U.S. Department of Energy
Office of Civilian Radioactive Waste Management

Subissue 3, Thermal-Mechanical Effects on Underground Facility Design and Performance - Component 3, Thermal Effects on Flow into Emplacement Drifts

**DOE-NRC Technical Exchange on the Key Technical Issue
and Subissues Related to Repository Design and Thermal-
Mechanical Effects**

**February 6-8, 2001
Las Vegas, NV**

Figure 1. Parameters Used for Calculation of Mode II Stress Intensity Factor

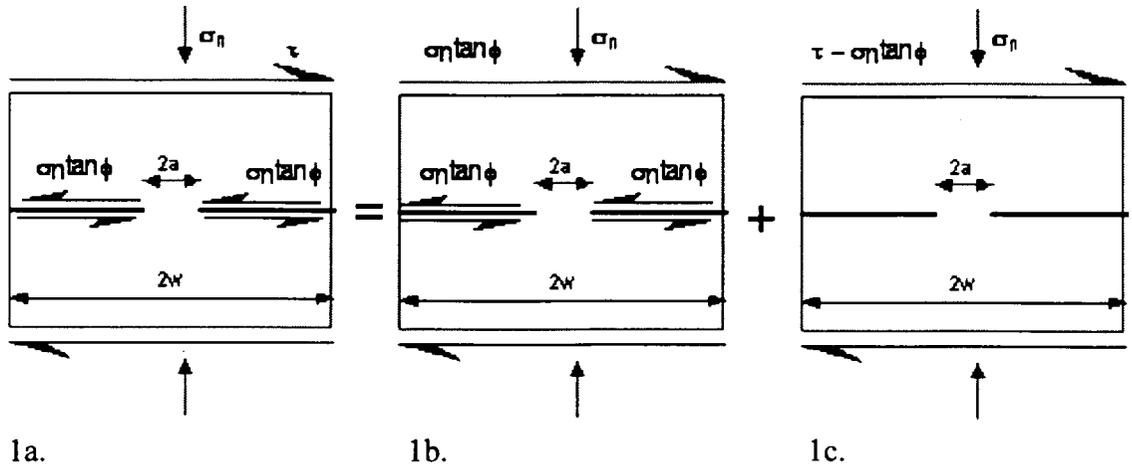
- (6) Provide clarifications for the following items: It is not clear how Equations (I-1) and (I-2) have been developed following Kemeny (1991) and Kemeny and Cook (1986). Contrary to what is assumed in Attachment I, a crack propagating under mode II shear load will not propagate in a direction along the crack axis. Equation (I-3) suggests an inherent assumption of sub-critical crack growth. However, by definition, a joint (crack) cannot continue to grow within an existing crack segment.

RESPONSE: Somewhat expanded derivations for Equations (I-1) and (I-2) are given as follows:

Consider a single asperity of width $2a$ contained in a body of width $2w$ under a far-field shear stress τ and normal stress σ_n , as shown in Figure 1a. Also, assume ϕ is the friction angle for the joint surfaces on either side of the asperity. This will result in frictional stresses along the joint surfaces of $-\sigma_n \tan \phi$.

By linear superposition, the body under the boundary conditions in Figure 1a is equivalent to the sum of the same body with boundary conditions shown in Figures 1b plus those shown in Figure 1c. In Figure 1b the body is subjected to a far-field shear stress $\sigma_n \tan \phi$ and a normal stress σ_n along with frictional stresses along the joint surfaces of $-\sigma_n \tan \phi$. In Figure 1c the body is subjected to a far-field shear stress $\tau - \sigma_n \tan \phi$ and a normal stress σ_n but no tractions along the joint surfaces. Note that Figure 1c is a frictionless problem and can be handled by standard fracture mechanics theory. The boundary conditions in Figure 1b result in no deformation and no stress intensity factor and can be discarded. Therefore from the standpoint of fracture deformation and stress intensity factor, Figure 1a is equivalent to Figure 1c. From Rooke and Cartwright (1976) the mode II stress intensity factor for the geometry and boundary conditions shown in Figure 1c is given by:

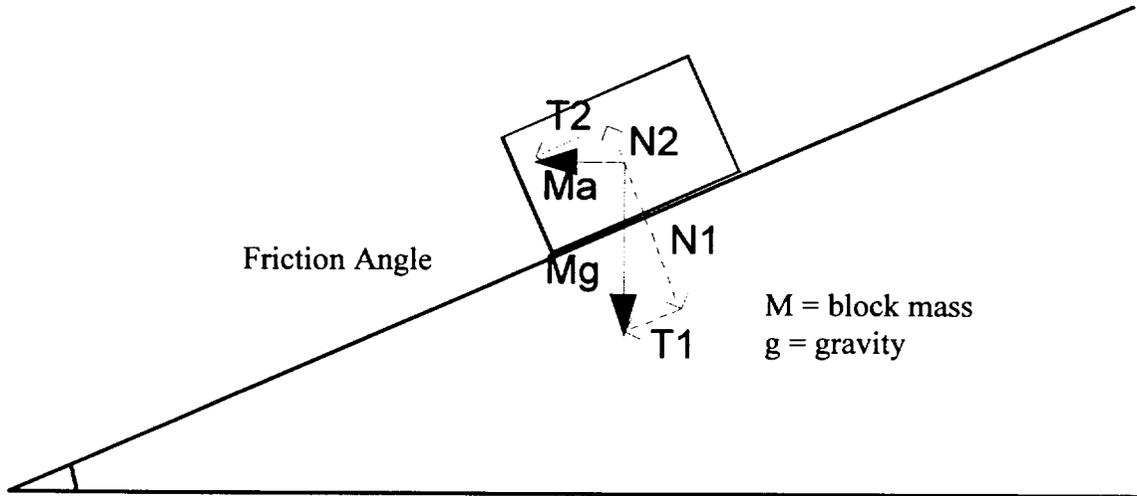
- (2) Demonstrate how the inputs to the verification model will be reasonably identical to the inputs used for the DRKBA model with respect to the following:

- 1) Fracture network

- 2) Thermal and mechanical properties
- 3) Thermal loading
- 4) Seismic loading
- 5) Calculated rockfall size distribution
- 6) Calculated emplacement-drift geometry

RESPONSE: DOE will respond to this during the Technical Exchange for RDTME.
